SUBJECT: Provides response to NRC request for addl info re svc water  
 sys.Responses,together w/commitments made & info provided  
 throughout insp period provided sufficient detail to support  
 closure of issues raised during insp.

Subject: Additional Information-Service Water System  
R.E. Ginna Nuclear Power Plant  
Docket No. 50-244

## ATTACHMENT A

## 1 PUMP - INJECTION PHASE

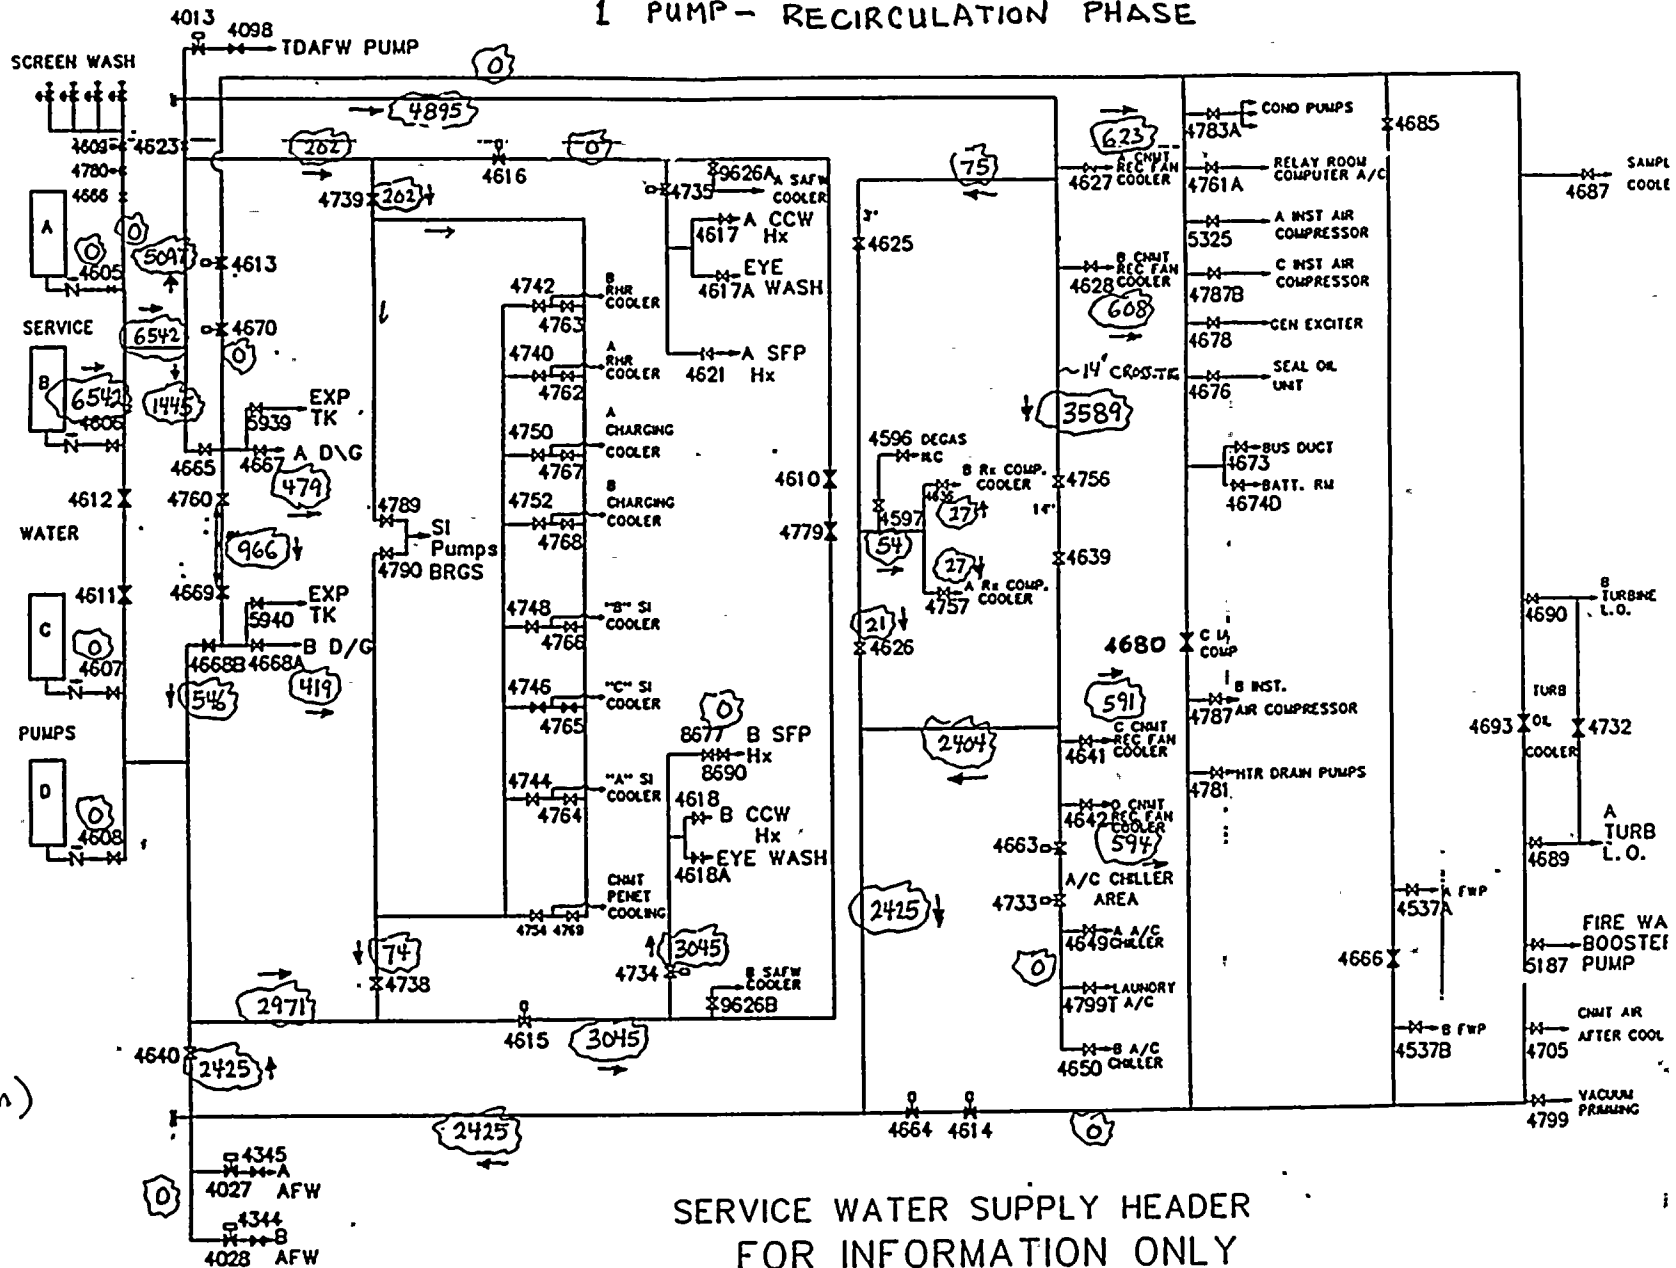
"Based on recent test results using the most limiting service water pump (corrected for worse-case lake level, water temperature, instrument inaccuracies, and pump degradation allowed under the inservice testing program), annotate on a simplified diagram of the SWS the pump discharge pressure, flow rates through each safety-related component, flow rates through non-safety-related supply lines (as applicable), and the system configuration/alignment that is necessary to satisfy the flow requirements for safety-related equipment. Also, indicate the electrical division (A, B or non-safety-related) where each component receives power. Describe how this system configuration/alignment will be achieved during an event assuming off-site power is available and also for the condition where off-site is not available, and identify specific time constraints that must be met in order to satisfy all accident analyses assumptions for heat removal. Provide conservative estimates of how long it will take to complete necessary actions for each case (i.e., off-site power available and off-site power not available). The basis for these estimations should be provided, which may include reference to previous plant experience, plant simulations and exercise walk-throughs."

The attached figures depict on a simplified diagram of the service water supply system the flows to the service water loads for the two cases of interest:

- 1) Injection phase, loss of offsite power, 1 service water pump
- 2) Recirculation phase, loss of offsite power, 1 service water pump

Our analysis of various system configurations were conducted using the enhanced service water system hydraulic computer model, Kypipe. The two cases above were examined in order to determine the minimum service water flow to the containment recirculation fan coolers (CRFC) with only one service water pump operating. These values became an input to our accident analysis performed for the one service water pump case reported in our letter dated September 1, 1992.

System runs were made in order to determine sensitivity to the service water header in operation and to produce the least flow through four fan coolers when only one service water pump is operating. For the injection phase the CRFC flow, including the cooling flow to the electric drive motor cooling coils, is approximately 900 gpm. Subtracting the motor cooler flow resulted in a CRFC flow of 840 gpm, the value used in the analysis. (See Question No. 3). Flow values for each of the separate smaller lines, such as safety injection pump bearings, and safety related pump area coolers have not been shown on the diagram individually, since their total does not represent a large load. The flowrates meet or exceed those typical values listed in UFSAR table 9.2-2 for the cases examined.
